## ADDENDUM #9

**Western Slope Food Bank of the Rockies**  
698 Long Acre Drive

**Bid Package #4 – Above Ground**

Architect's Project No. 2108

**HOOD DETAIL**

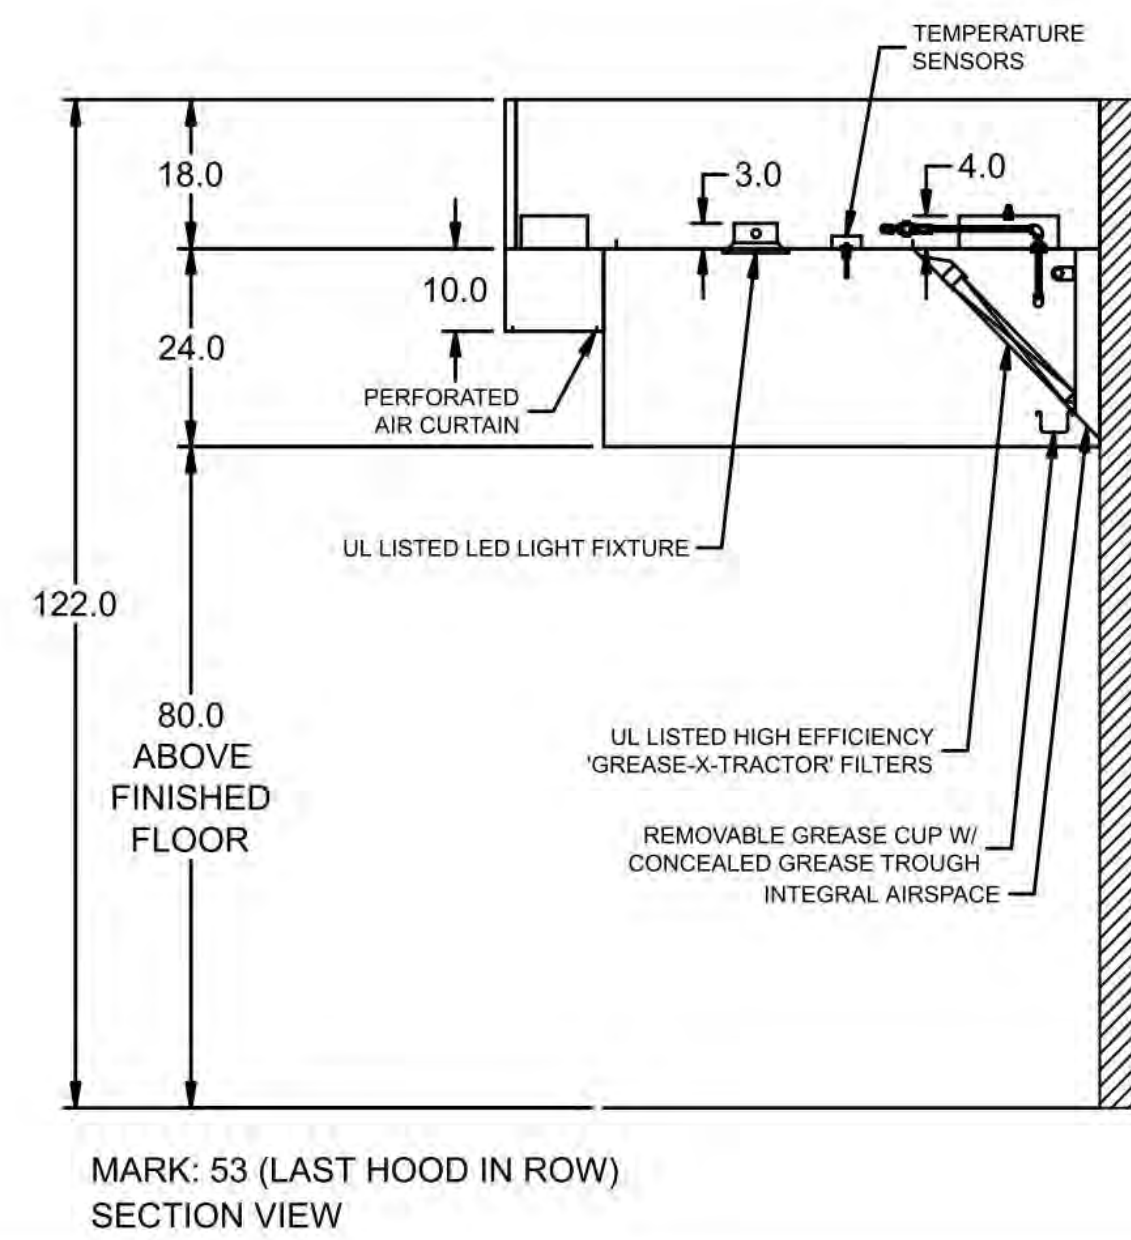
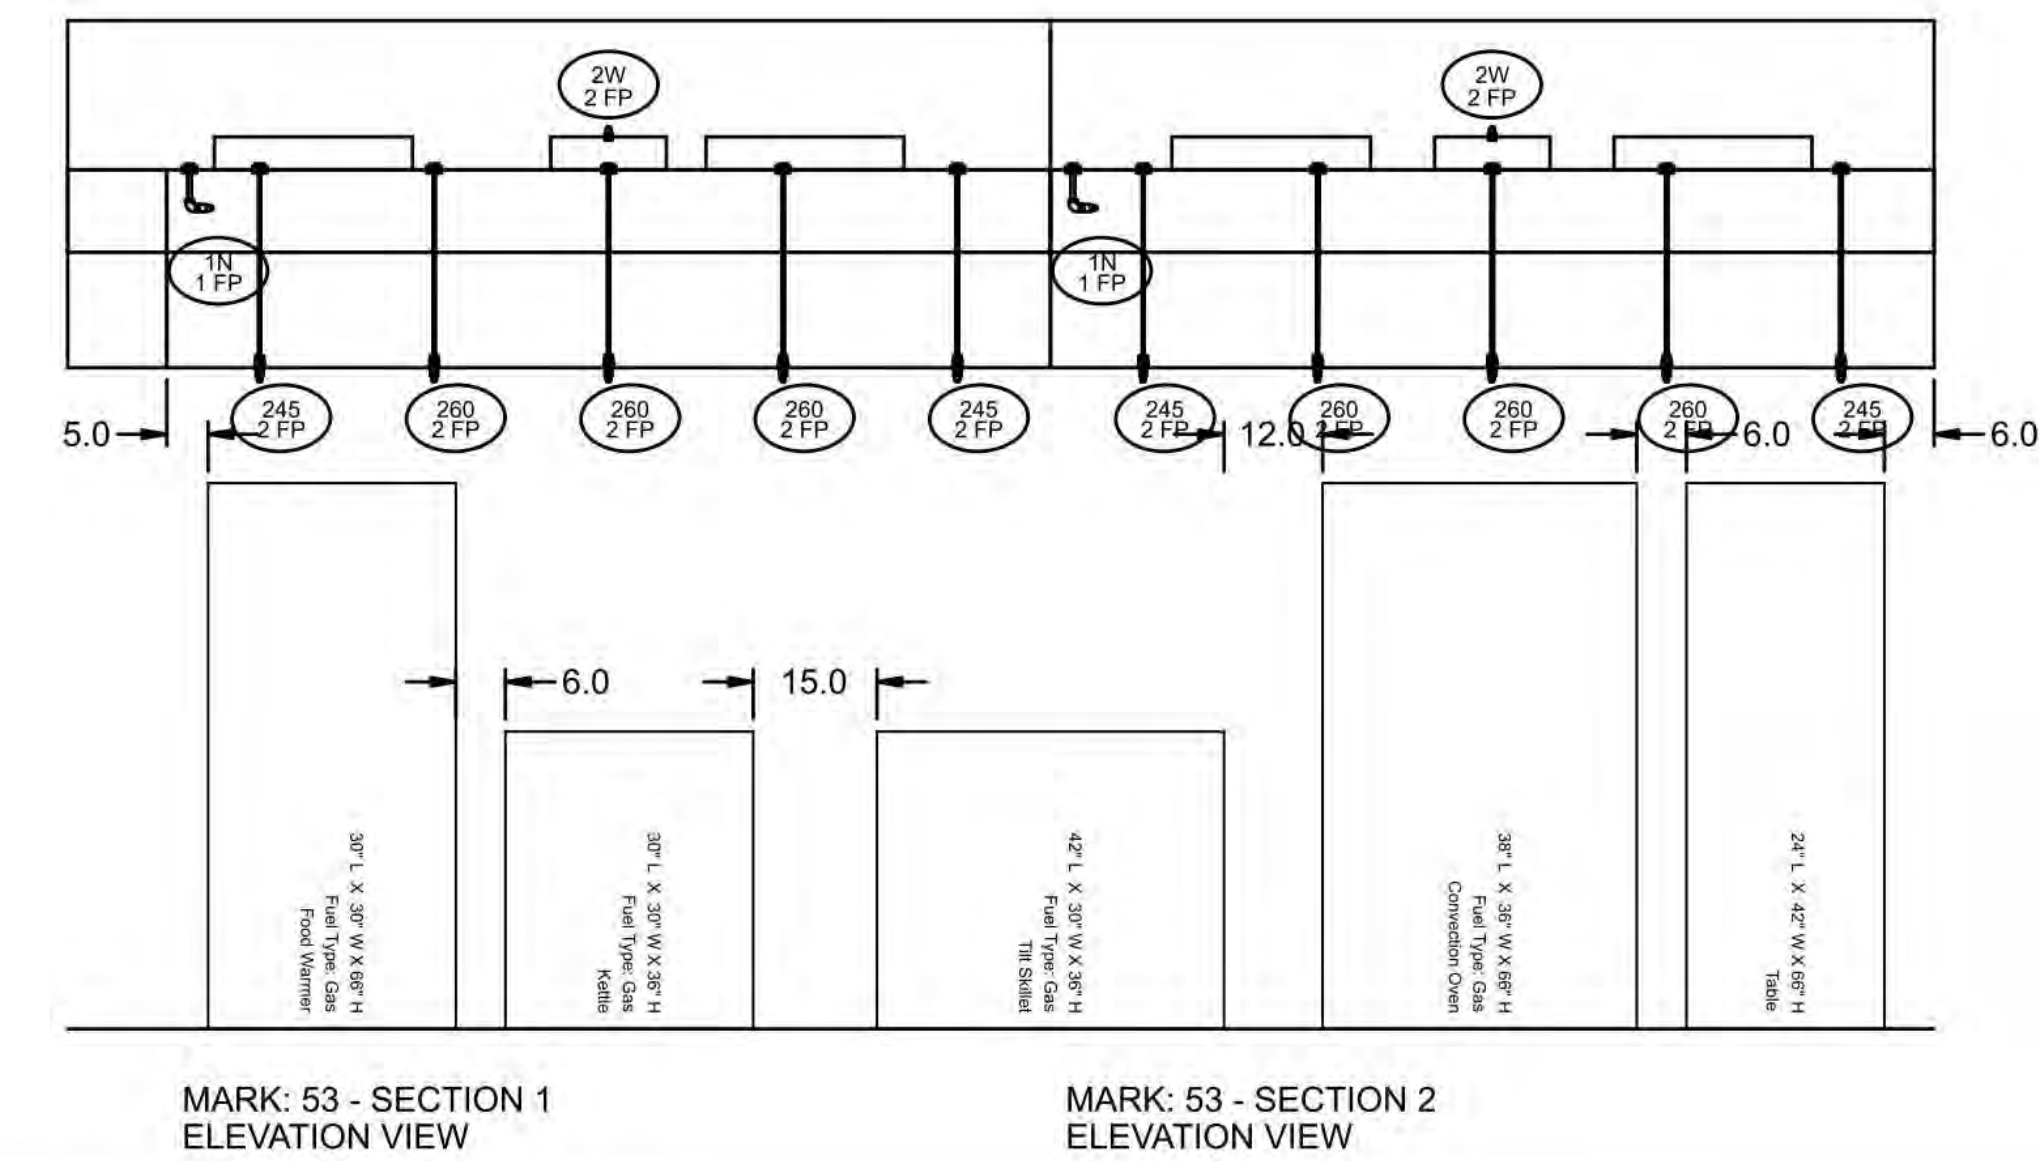
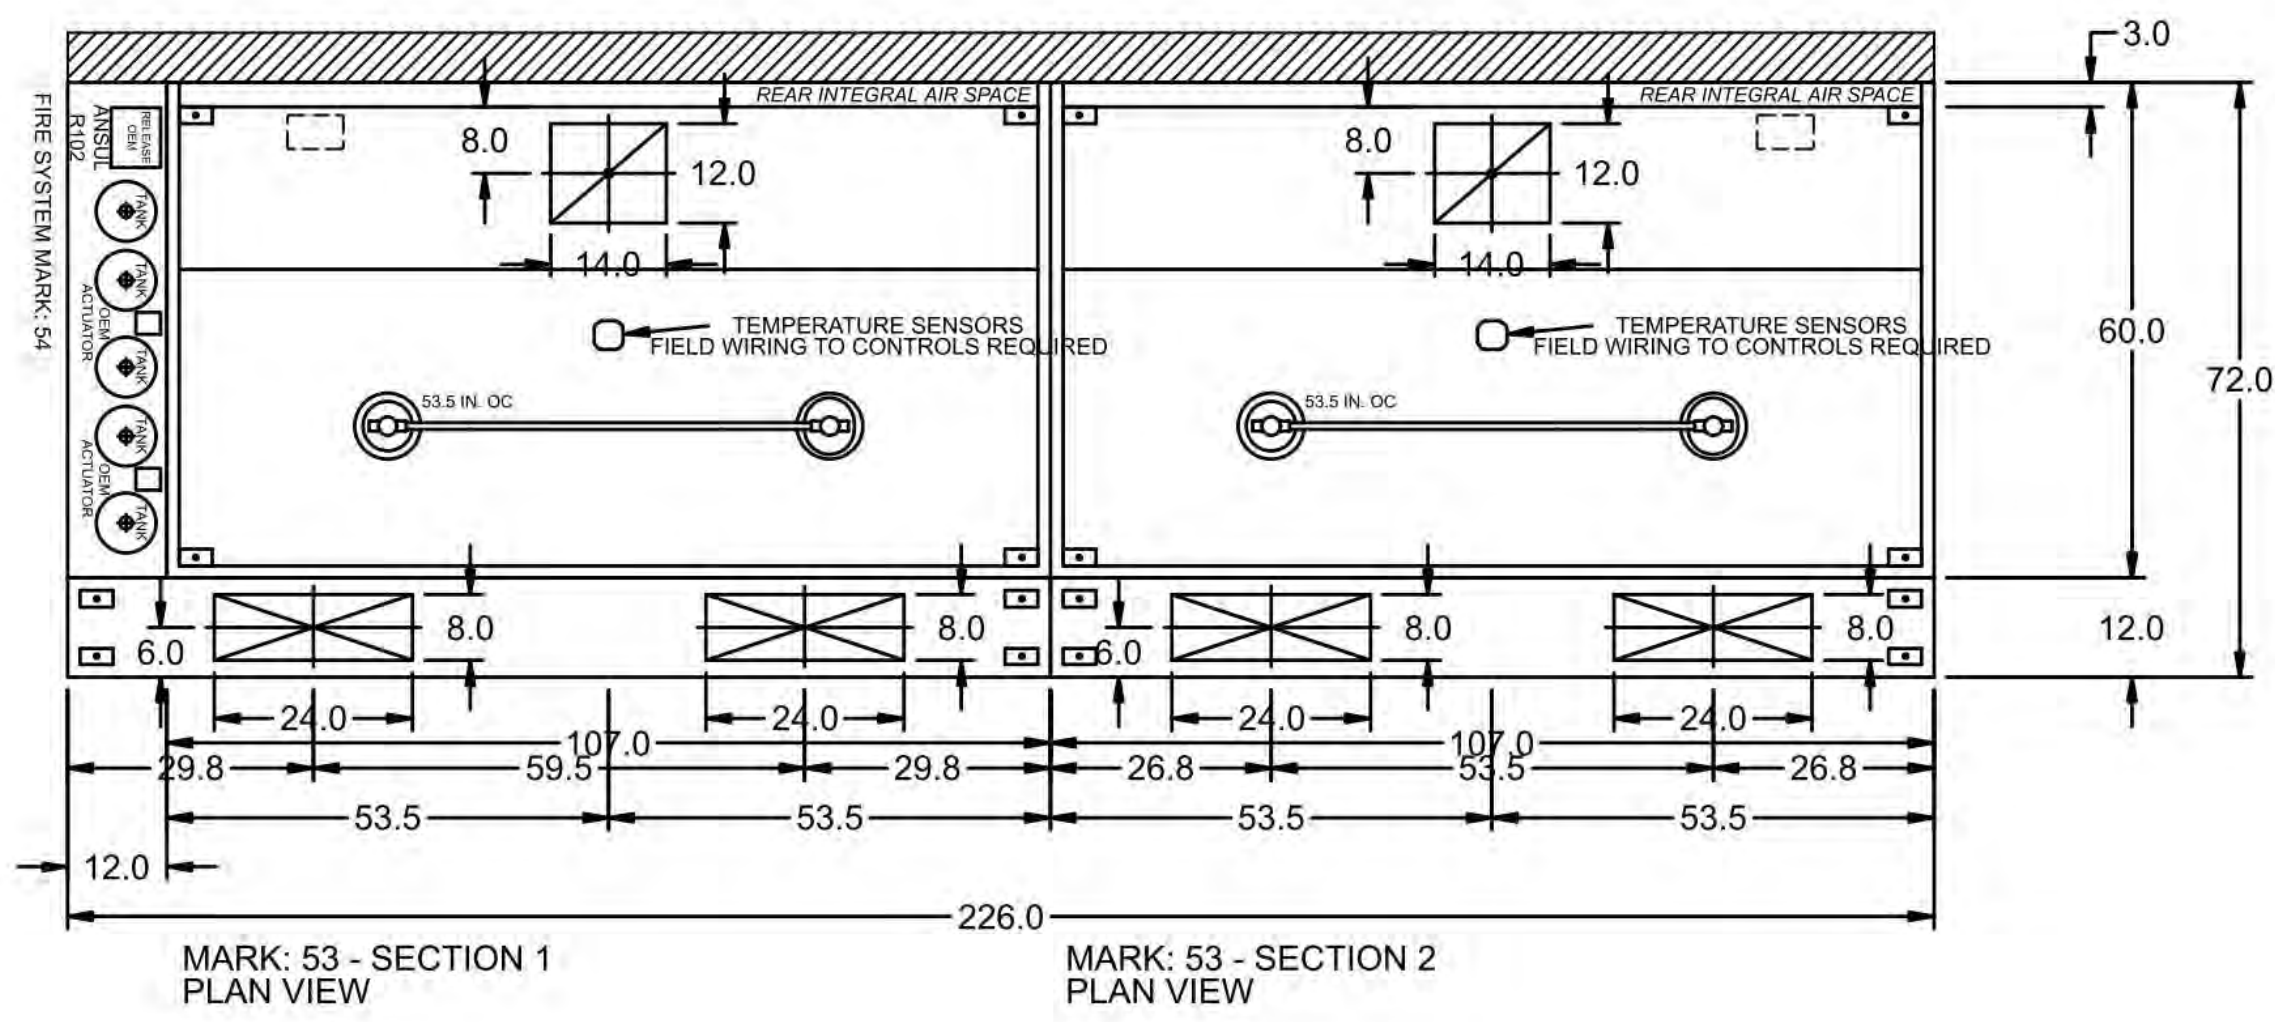
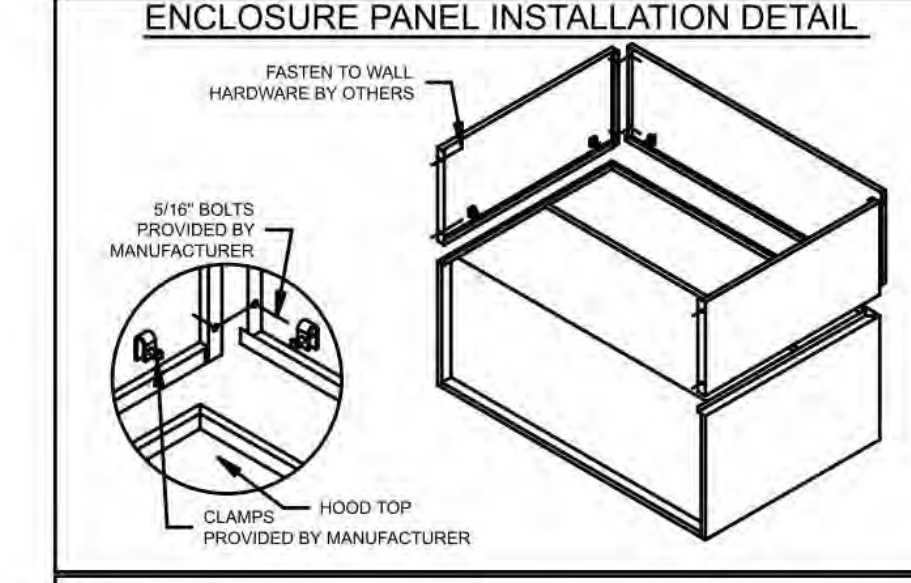
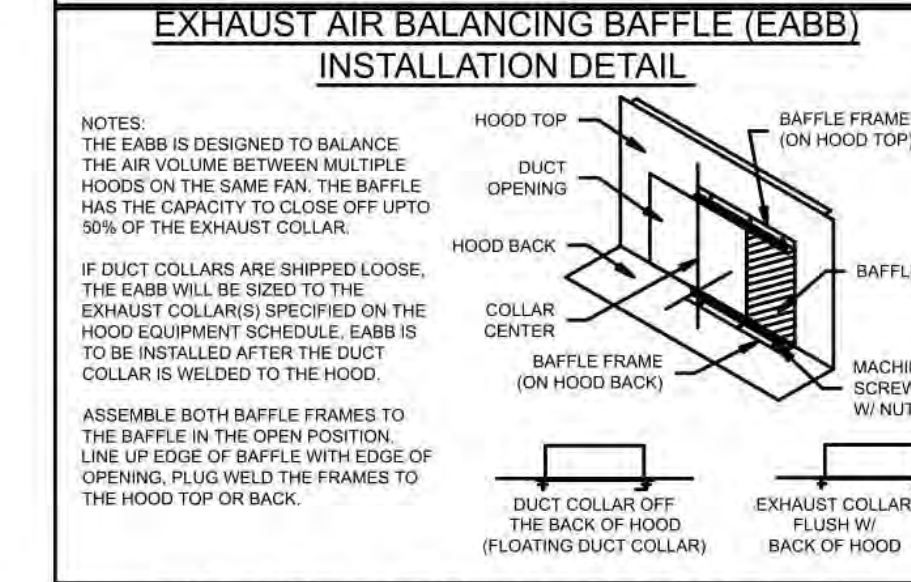
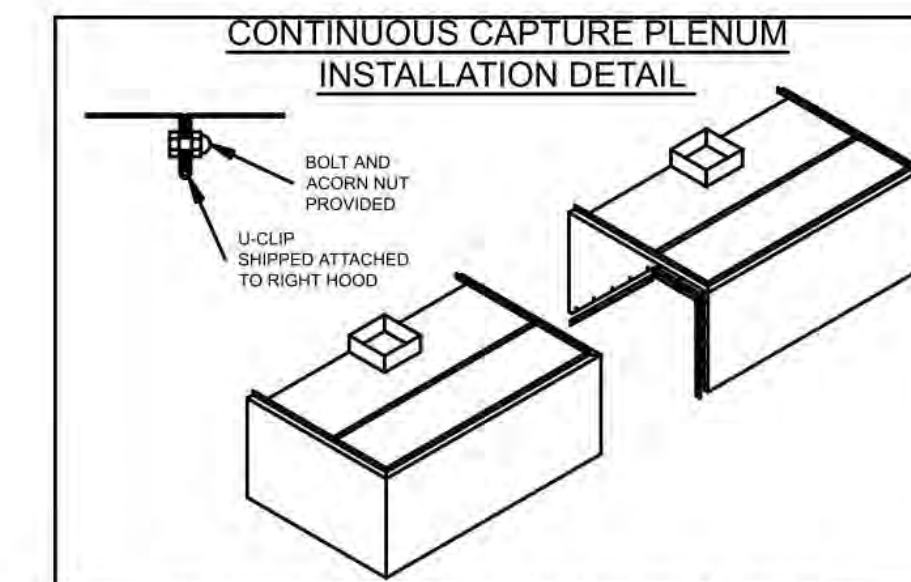
THE KITCHEN HOOD ASSEMBLY, FIRE SUPPRESSION SYSTEM, CONTROLS AND RELATED ACCESSORIES AS SHOWN OR SPECIFIED OR REQUIRED FOR COMPLETE AND FUNCTIONAL SYSTEM SHALL BE PROVIDED (FURNISHED AND INSTALLED) UNDER THIS CONTRACT.
